Series 42 Axial Piston Pumps

Size 28/32

Service Bulletin

Auxiliary pad adapter and gasket change

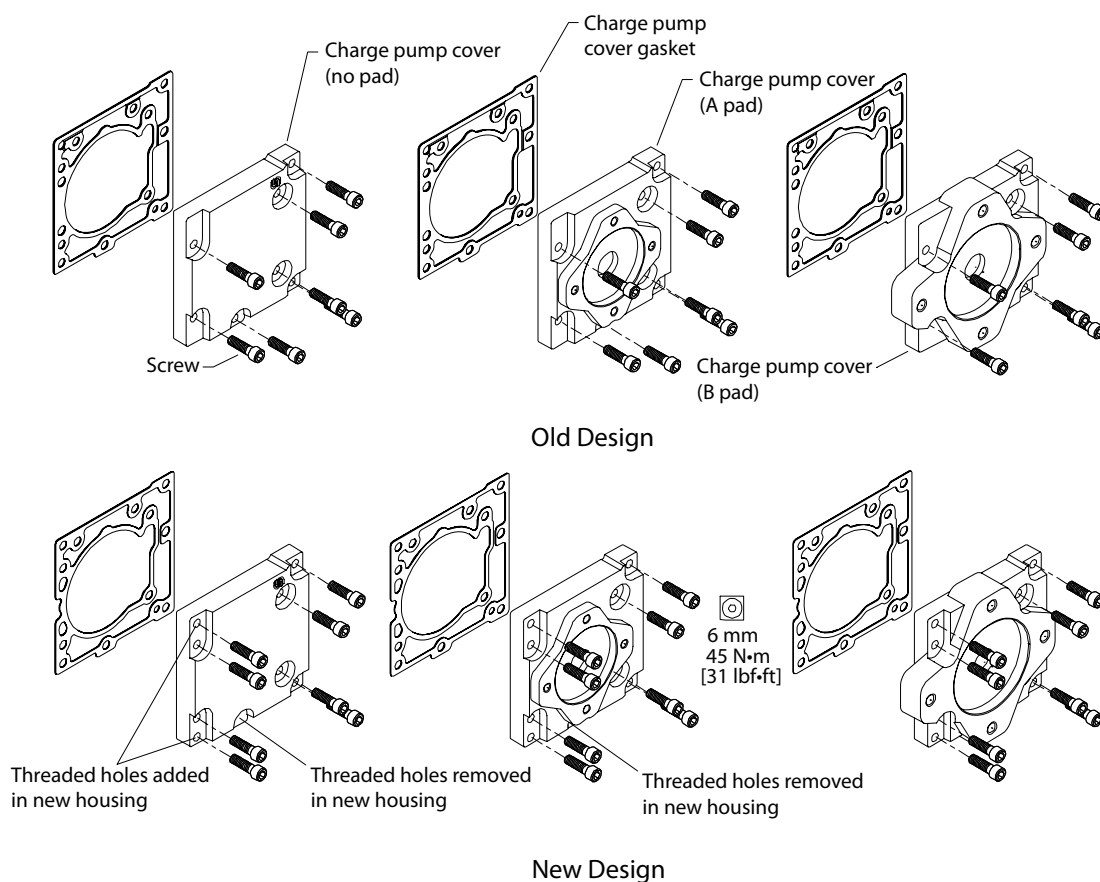
A design change has been made to the charge pump cover and cover gasket. The major change to the cover is the number of screws used. The old SAE "A" and non-auxiliary pad covers used seven screws, and the SAE "B" used six screws to attach the cover to the housing. The new covers will each use eight screws. The new eight screw design is interchangeable with the old design. Place screws in the cover where the pump housing has a threaded hole for a screw. Older vintages of pumps used torx head screws (T-45). Newer vintages use internal hex cap head fastener (6 mm).
